SERVICE BULLETIN

RIDE: Ranger (aka: Phoenix, Kamikaze, Hi-Flyer)
SUBJECT: Secondary Latch Bolt Support

DATE: January 28, 1993
BULLETIN #: FRO32

DETAIL A

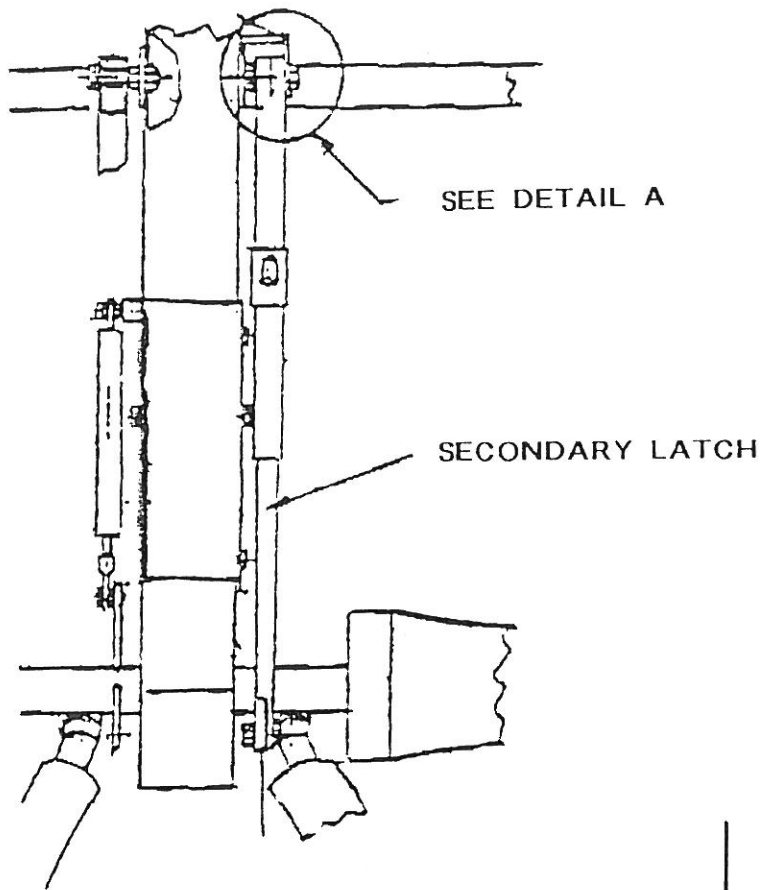
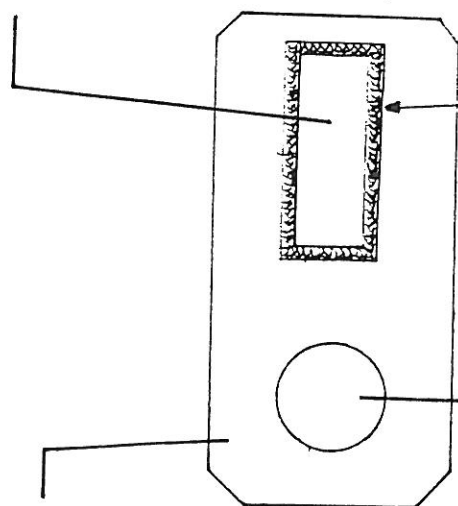
It has been brought to the attention of FarFabbri, s.r.l., that when the lap bar solenoid releases and the patron slams the bar against the secondary latch, the top bolt of the secondary latch will eventually break off.

This can be prevented by installing a bolt support as shown in the following drawings.

MATERIAL SIZE 1" x 3/8"

MATERIAL SIZE 1 1/4" x 1/4"
